[Docket No. 92-CE-63-AD; Amendment 39-9251; AD 95-12-01]

Airworthiness Directives; Piper Aircraft Corporation PA-25 Series Airplanes

Appendix to AD 95-12-01—Procedures and Requirements for Wing Forward Spar Attachment Assembly; Inspection of Piper PA-25 Series Airplanes

FIGURE 1

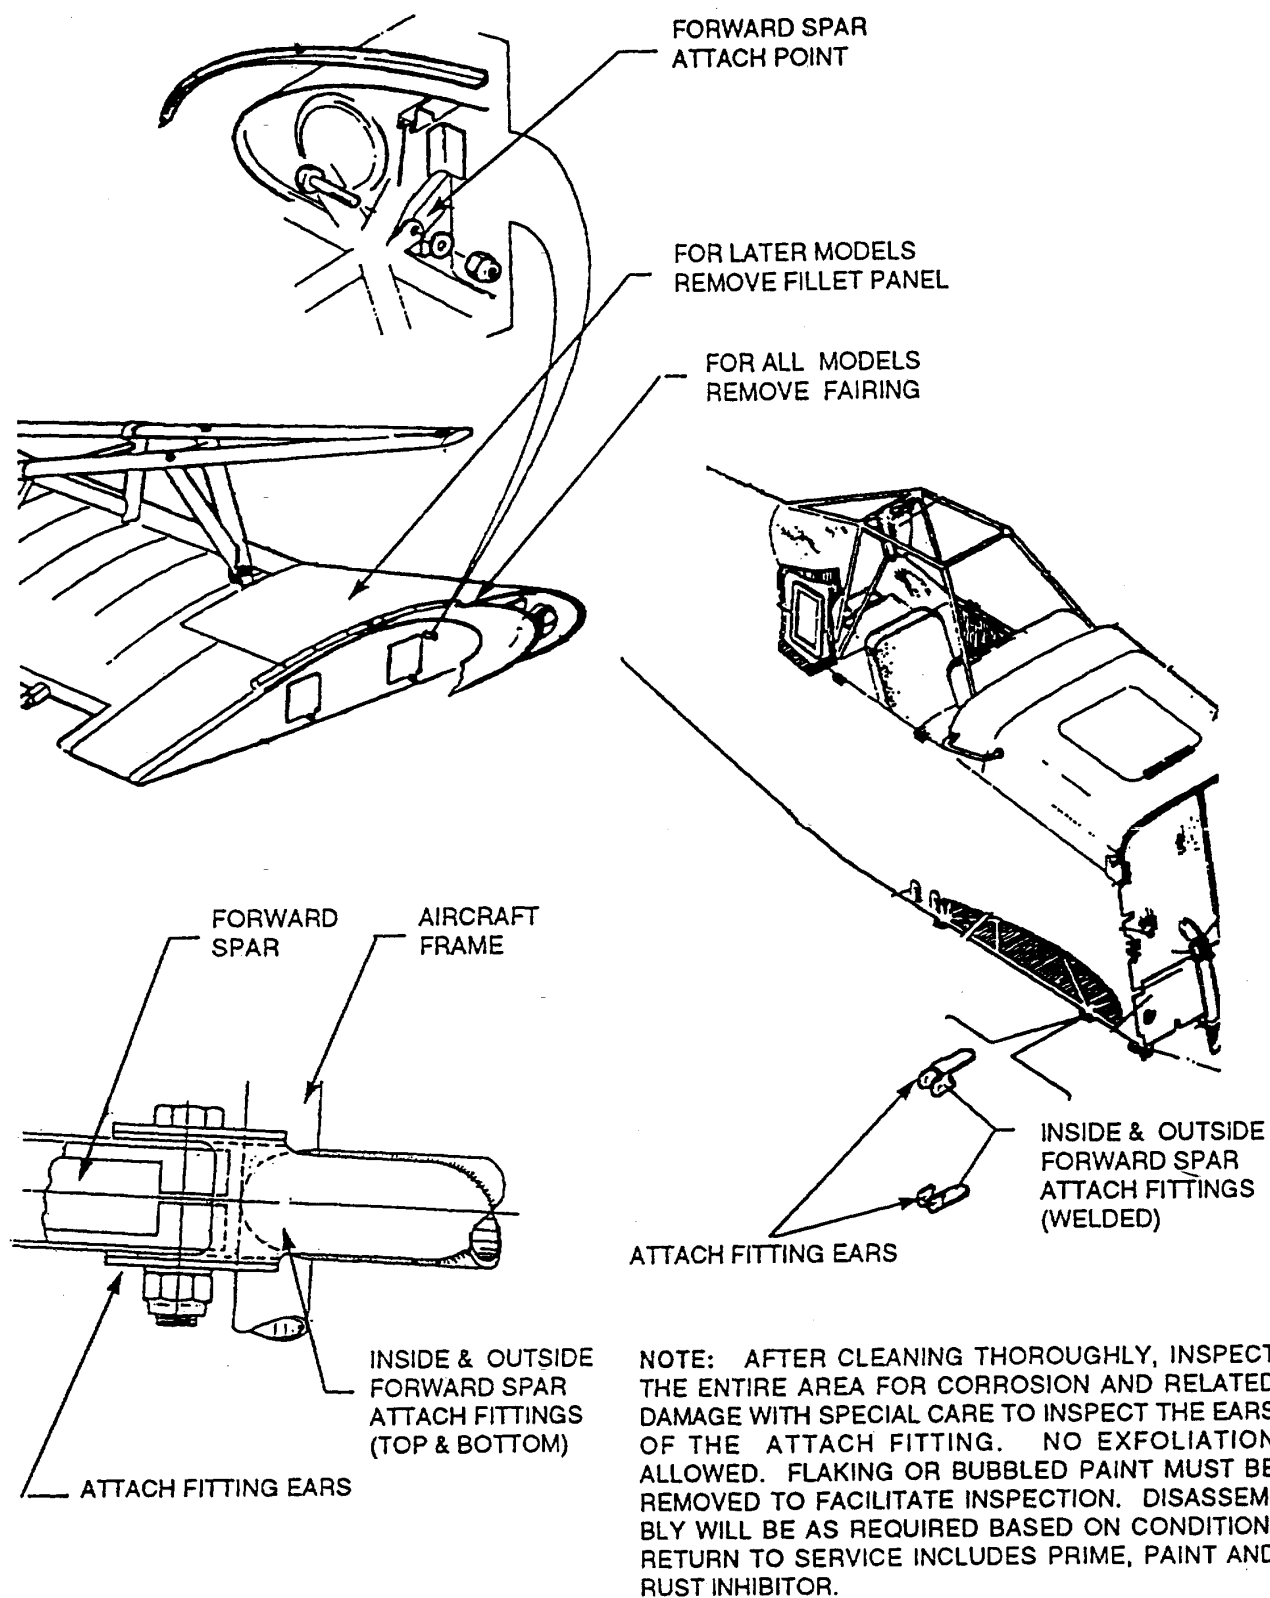
(a) Gain access to the left and right wing forward spar fuselage attach fittings by removing the screws retaining the wing fairing. Dismantle the wing fillet by removing the screws on the aft edge top and bottom and removing the wing fairing (see FIGURE 1 of the Appendix to this AD).

Figure 2

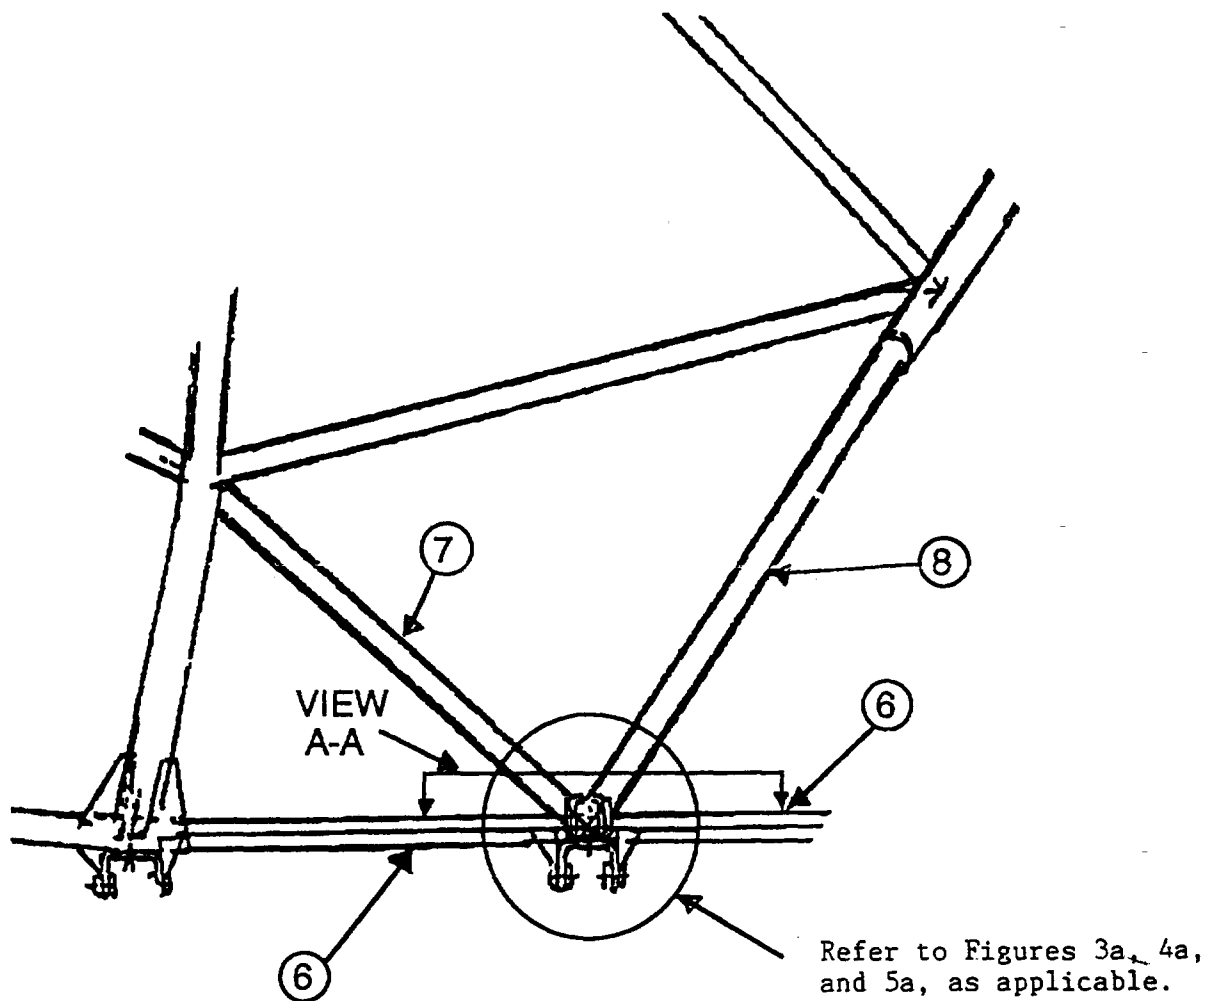
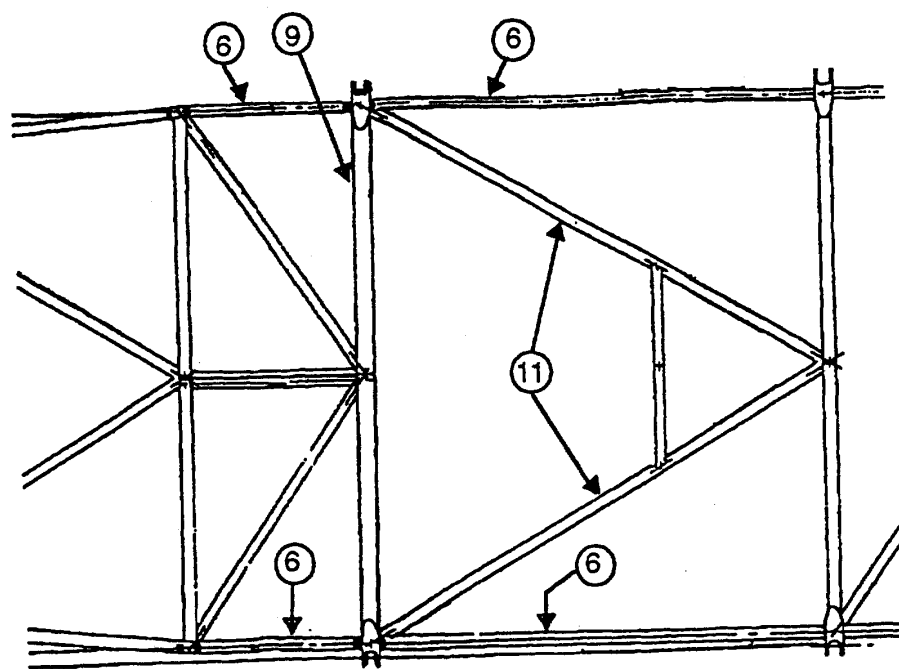
b. Cut the tubular members as referenced and specified in Figure 2 and either Figures 3a and 3b; Figures 4a and 4b; or Figures 5a and 5b, as applicable.

2. Cut the tubular members as referenced and specified in Figure 2 and either Figures 3a and 3b; Figures 4a and 4b; or Figures 5a and 5b, as applicable.

Figure 3a

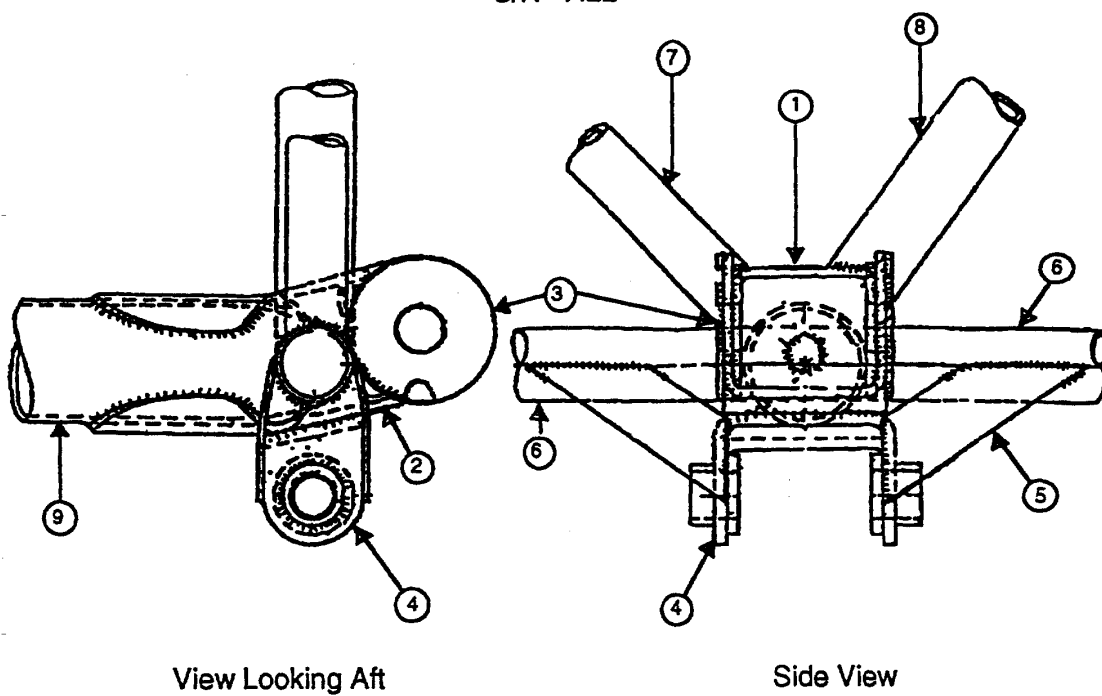
1. Add couplant to the outside inspection surface (Refer to Figures 3a, 4a and 5a, as applicable). Add the appropriate gain to obtain the backwall echo from the inspection surface. If the gain setting is adjusted, re-check the thickness values on the steel shims. To assure proper coupling to the test sample, twist the probe clockwise and counter-clockwise (with a 45-degree twist) and maintain contact with the test surface. During the articulation of the probe, observe the A-trace on the screen and stop the probe twist at the point of adequate back surface signal amplitude to trigger the thickness gate

2. Add couplant to the inside inspection surface (Refer to figures 3a, 4a and 5a, as applicable). Add the appropriate gain to obtain the backwall echo from the inspection surface. To assure proper coupling to the test sample, twist the probe (clockwise and counter-clockwise with a 45-degree twist). During the articulation of the probe, observe the A-trace on the screen and stop the probe twist at the point of adequate back surface signal amplitude to trigger the thickness gate on the first half-cycle. Measure and record the thickness. Repeat the above process at eight equally-spaced locations around the surface.

(e) Replacement parts required by this AD shall be of those referenced and specified in either Figures 3a and 3b, 4a and 4b, or 5a and 5b (as applicable), included as part of the Appendix of this AD.
